**LEBANON PLANNING BOARD
AUGUST 12, 2024 - 6:30 PM
COUNCIL CHAMBERS, CITY HALL OR
REMOTE VIA VIRTUAL PLATFORM
LEBANONNH.GOV/LIVE**

- A. **Brickyard One Nominee Trust, 174 Hanover Street (Tax Map 48, Lot 4), 0 Hanover Street (Tax Map 48, Lot 2), 0 Hanover Street (Tax Map 48, Lot 1), and 238 Hanover Street (Tax Map 63, Lot 1), zoned R-1, R-O-1, R-3 & RL-3:** Request for Site Plan Review and a Conditional Use Permit pursuant to Sections 308.2, 310.2, 311A.2, and 501.2 of the Zoning Ordinance for a proposed 474-unit multi-family Planned Unit Residential Development (PURD) totaling +/- 731,600 sq. ft. in size, consisting of 11 buildings together with parking, utilities, landscaping, access, and other related site improvements. Applicant also requests a Conditional Use Permit pursuant to Section 308.4 of the Zoning Ordinance to allow an increase in the maximum permitted building height from 45 ft. to 55 ft. **PB2024-22-CUPSPR - Continued from July 8, 2024**

**RE: July 8, 2024 Planning Board Meeting - Agenda Item 4.A
Marlee Dixon/Greg Hagley Appeal of Impact Fee Assessment -
78 Bank Street (Tax Map 92, Lot 106), Zoned R-O**

Drawing Number
C3.3
Sheet 13 of 50
Project Number
52933.00

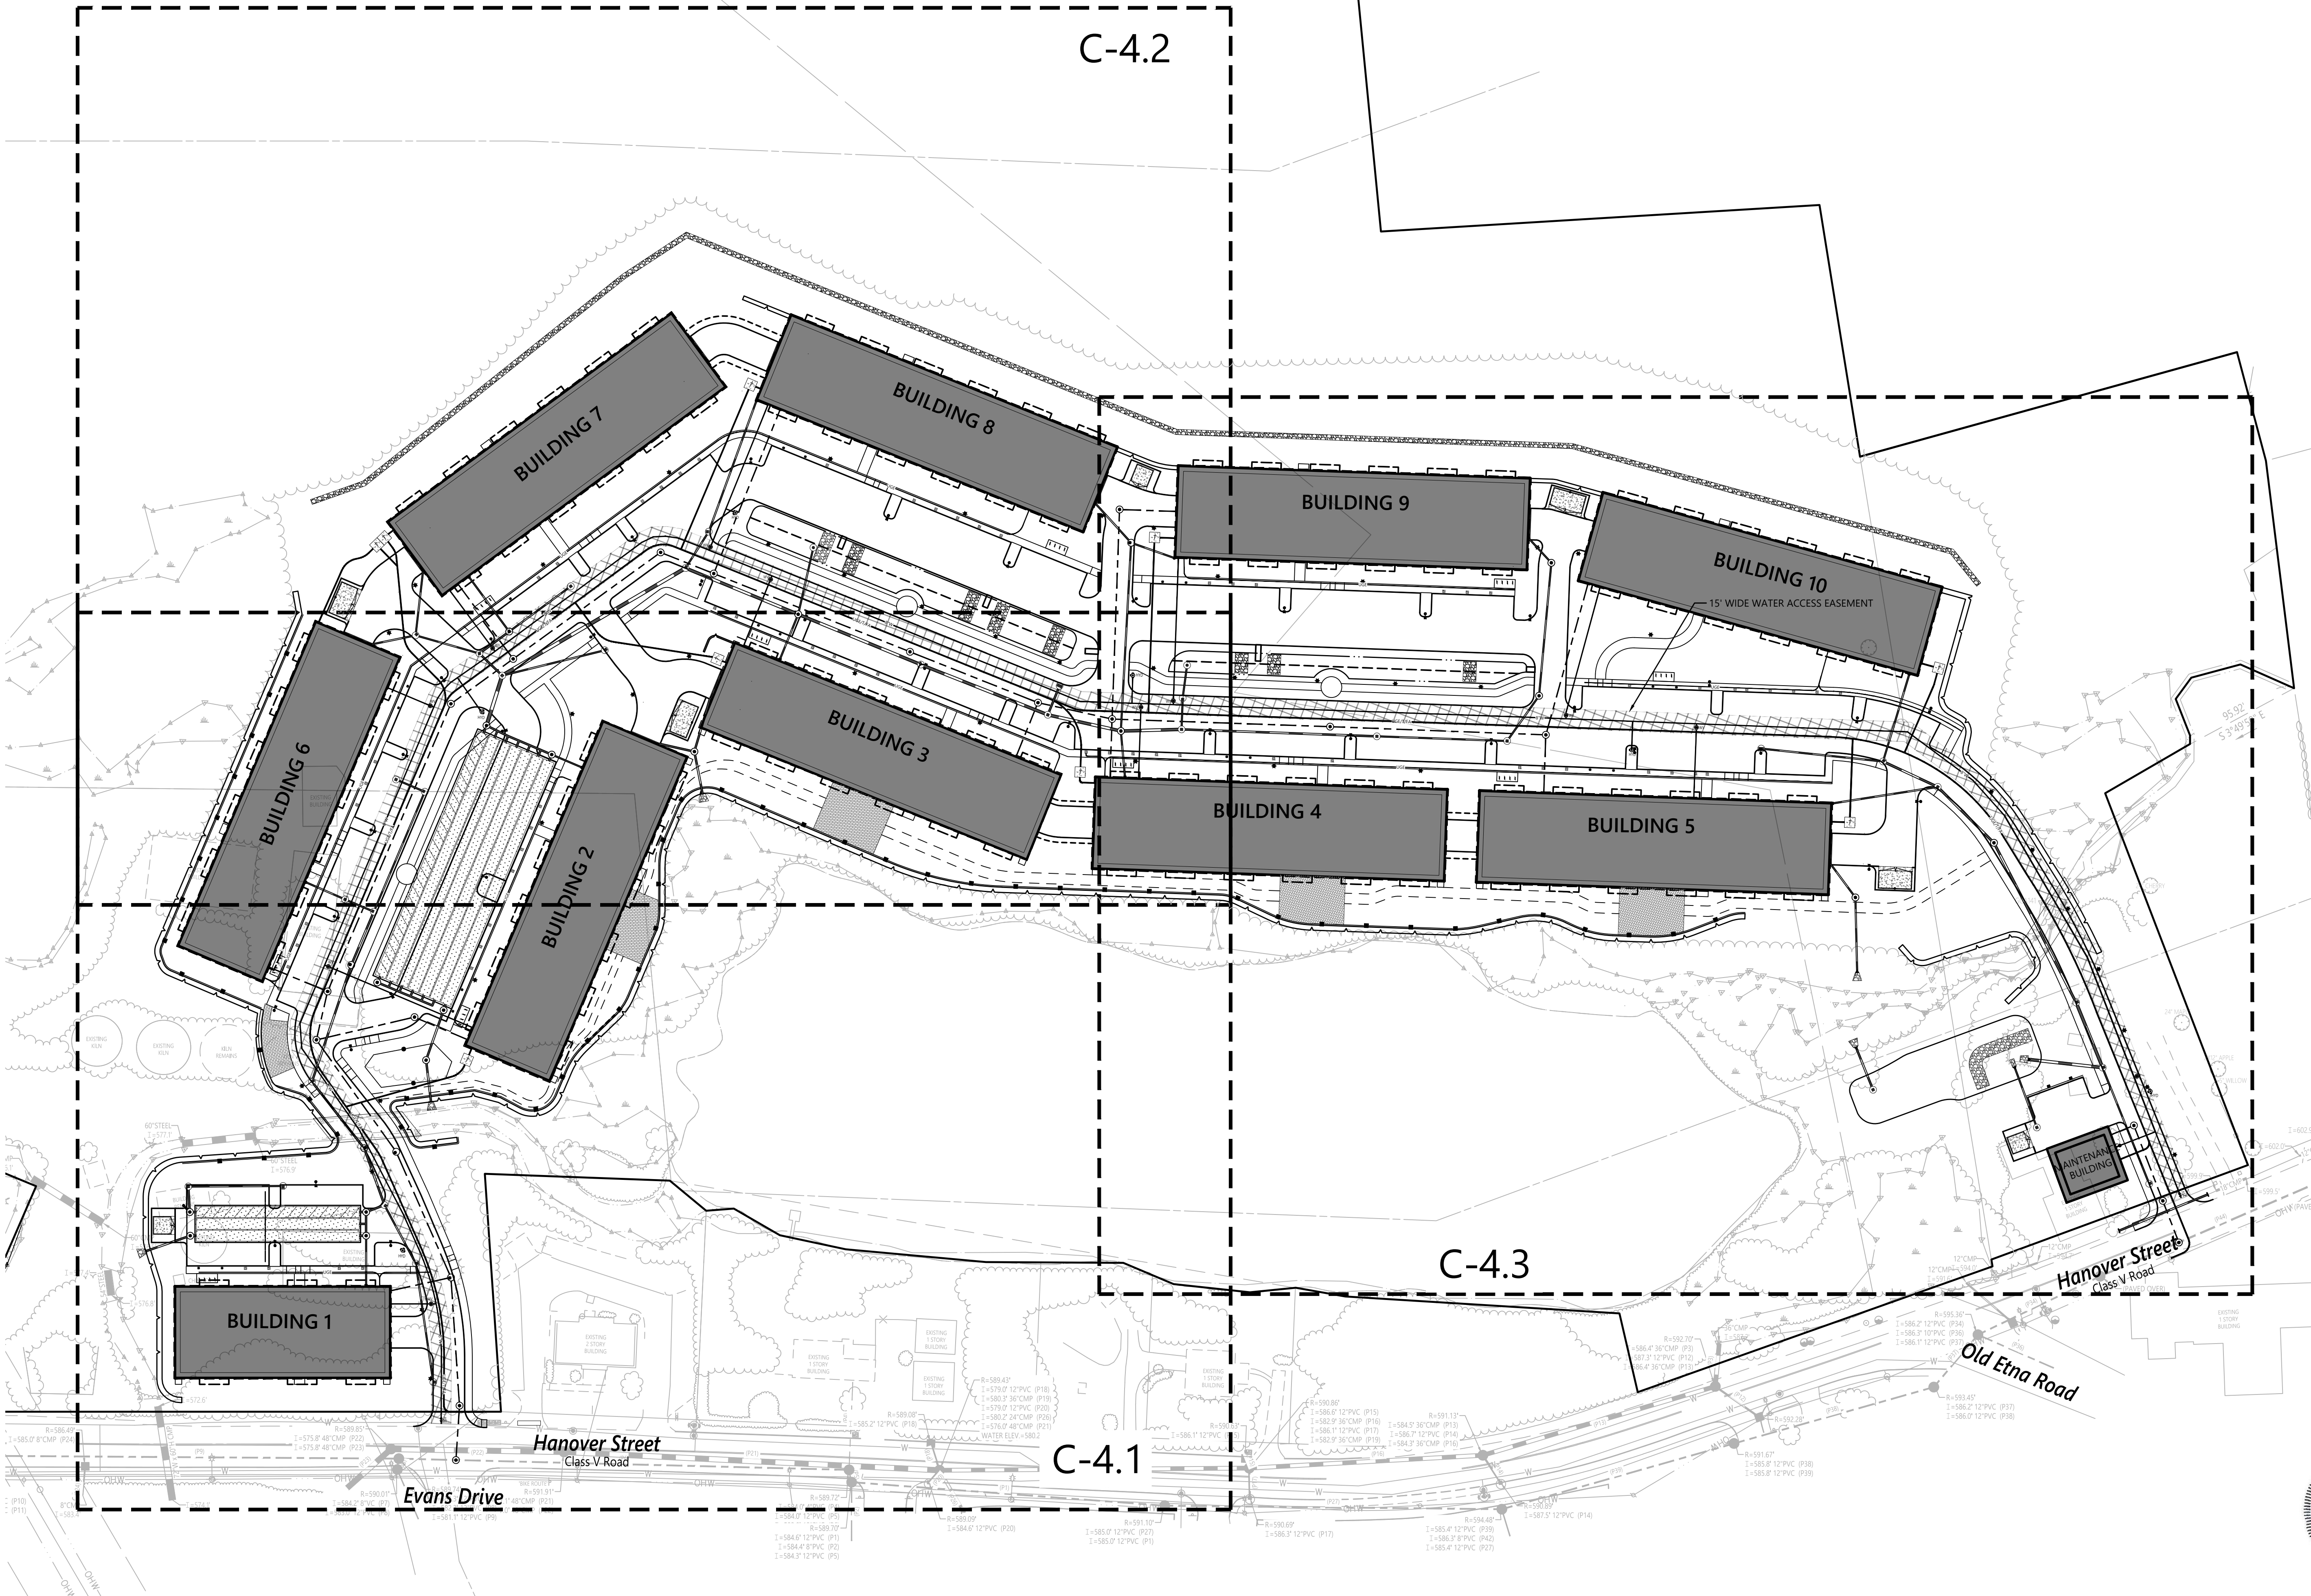
- Text providing information pertaining to proposed cut slope construction was inadvertently “cropped” from the top of the drawing image shown on Sheet C3.3.

- As shown on Sheet C3.3 construction of an excavated 1.5:1 embankment is planned to the west of Buildings 7 through 10. To the west of Building 10 the vertical embankment height will exceed 40-feet. We recommend: (a) completion of geotechnical exploration sufficient to confirm feasibility of and design parameters for this construction; and (b) introduction of vertical “benching” at intervals sufficient to permit convenient embankment construction and provide added slope stability.

- As shown on Sheet C3.3 curvilinear walkway construction is planned to the immediate east of Building 10 to provide exterior building access from adjoining parking. We recommend the addition of site-specific details of this construction to the drawings. Given the proposed embankment slope at this location, it appears exterior stair construction will be necessary. If so, what is the applicant’s proposal for providing ADA compliant access to Building 10?

- As shown on Sheet C3.3 a short length of fill embankment with a 2.3:1 slope is planned between Buildings 4 and 5. We recommend placement of safety rail or fence atop this slope.

Comment 19j. *"Text providing information pertaining to proposed cut slope construction was inadvertently "cropped" from the top of the drawing image shown on Sheet C3.3."*

C4.1

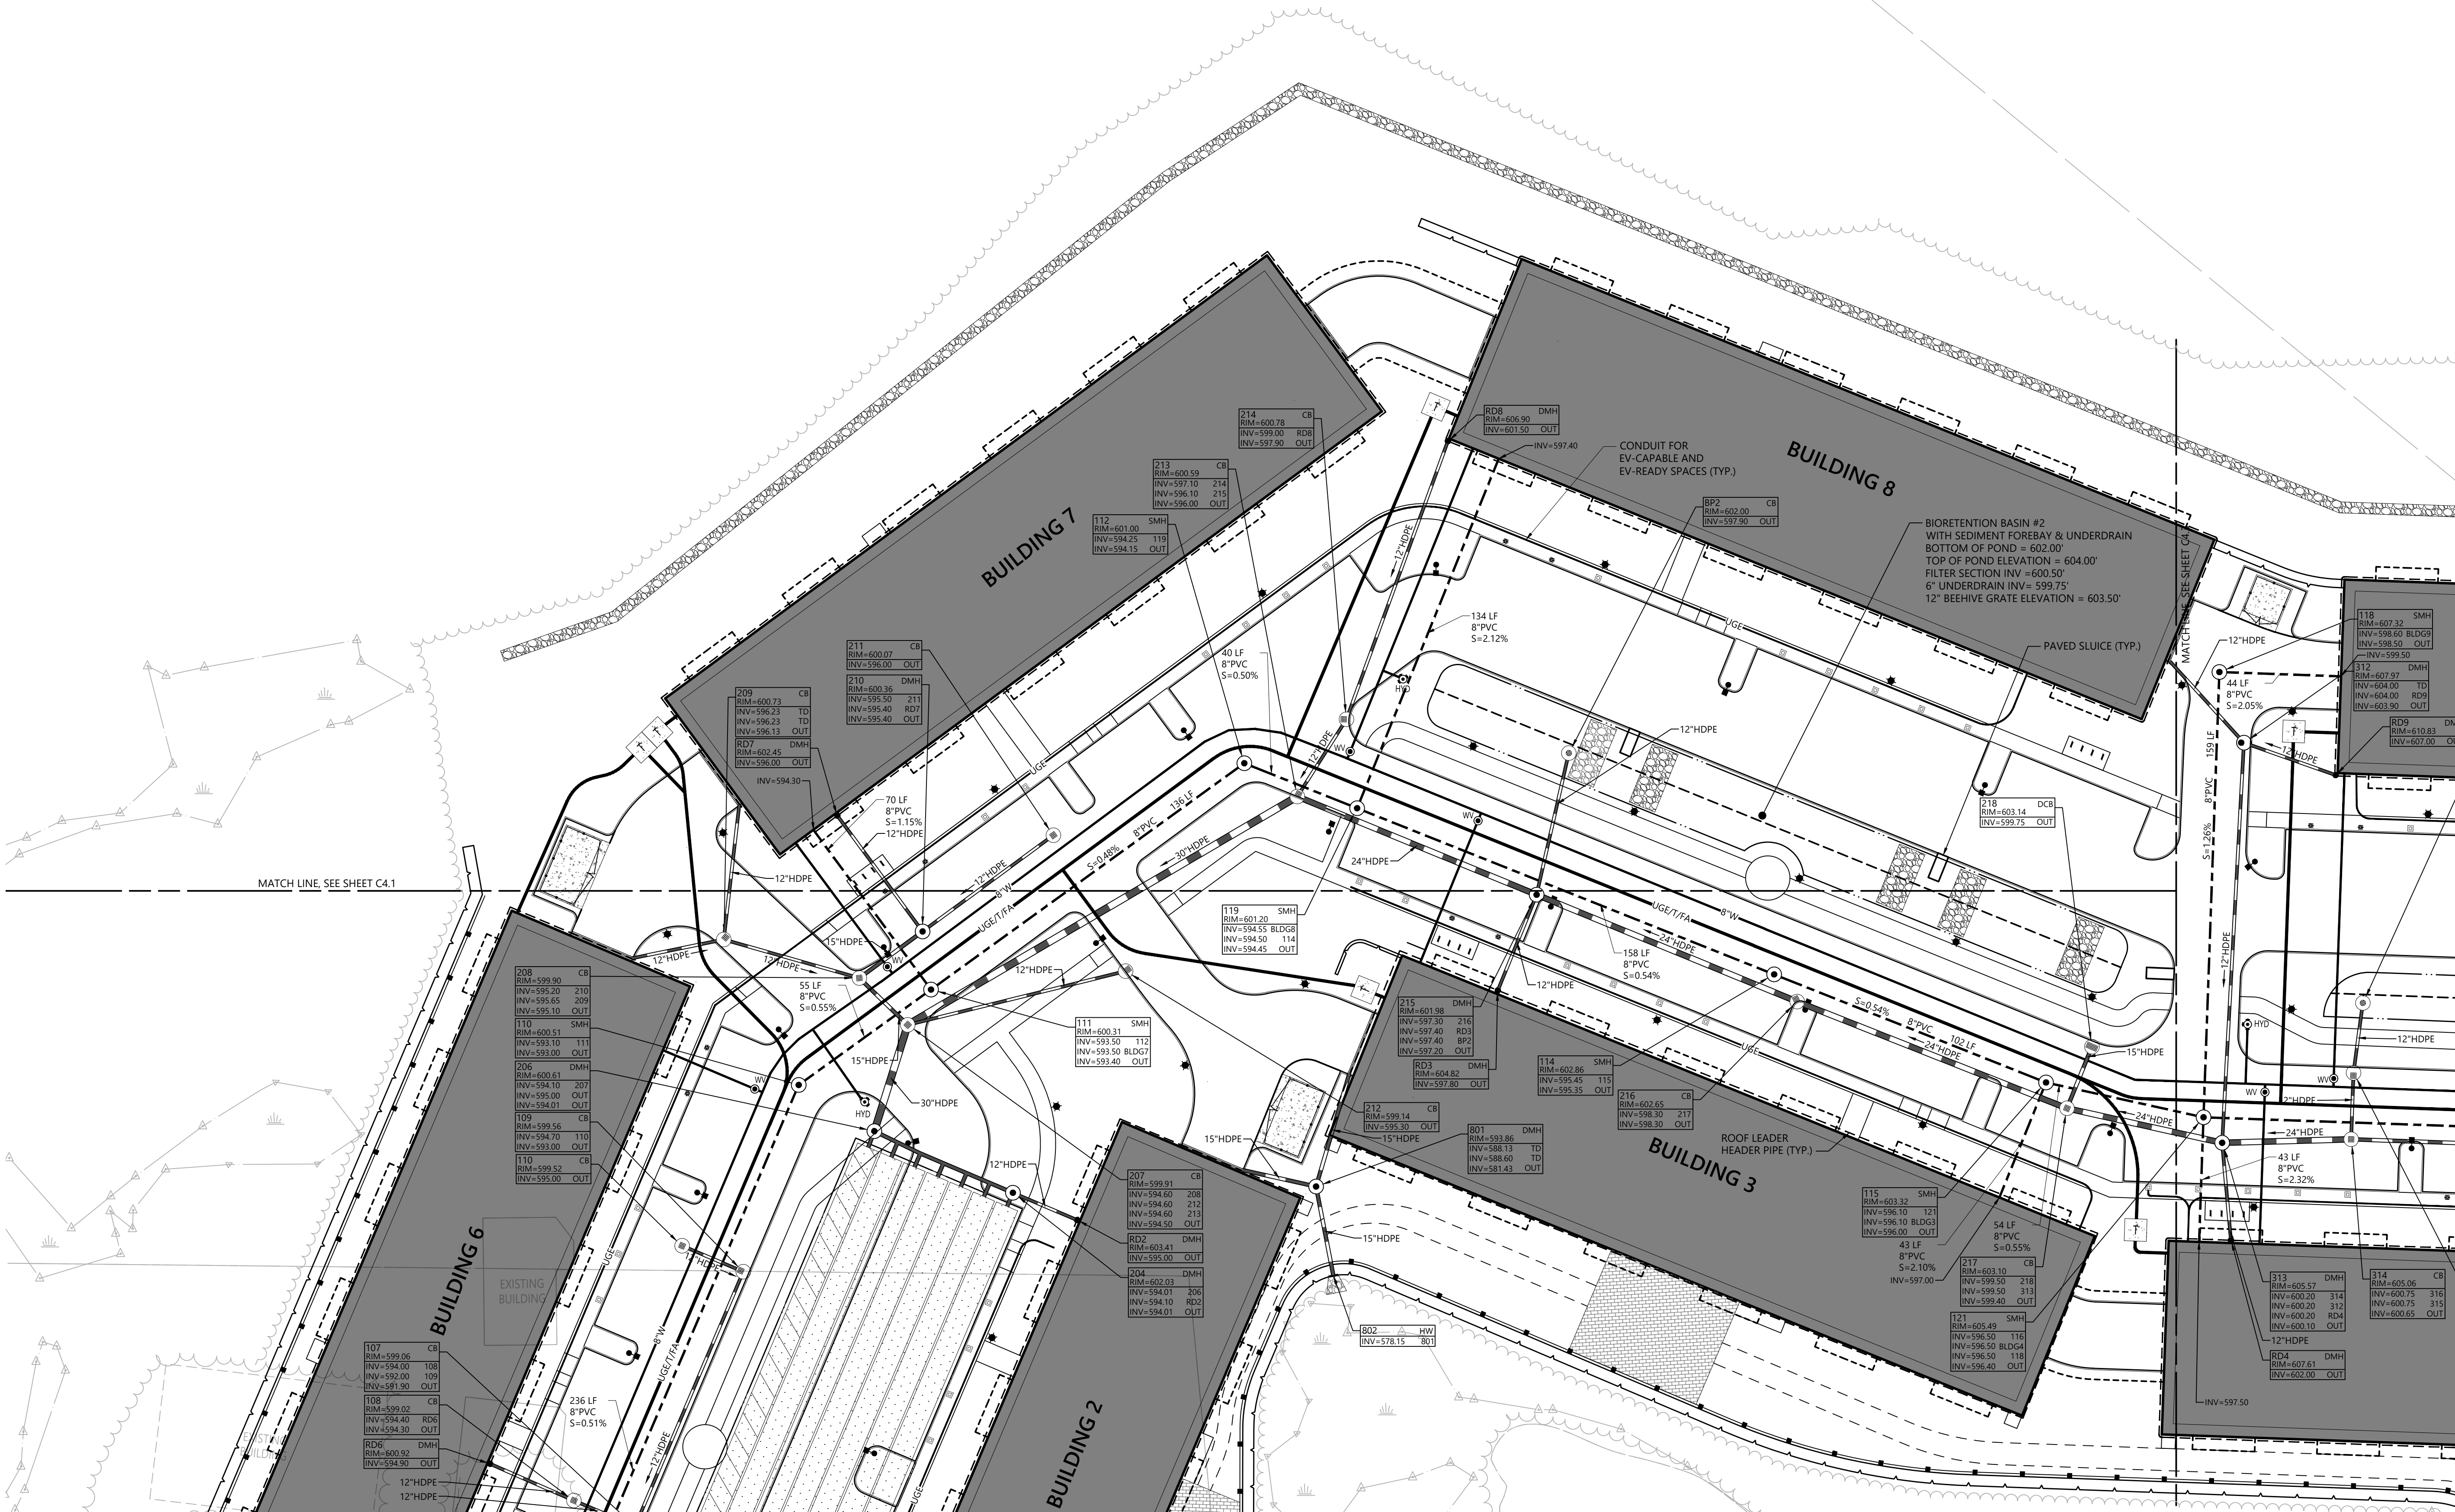
- Design elevations for DMH 204 provided on Sheet C4.2 suggests drainage structure “101” connects with the same. Structure 101 is neither shown nor labeled on the drawing image.

- For improved storm sewer hydraulics, we recommend matching pipe crown elevations of inflowing pipes of varying diameter at drainage structures. Design invert elevation values specified on Sheets C4.1 through C4.3 vary from this rule at several locations (Example: CB 207 shown on Sheet C4.1).

- We recommend the design engineer recheck design invert elevations for the segment of storm drain planned between CB 218 and CB 217 (See Sheet C4.1). An identical comment is offered regarding CB 314 and CB 315 shown on Sheet C4.2.

21. No water service connection to Building 1 is shown on Sheet C4.1.
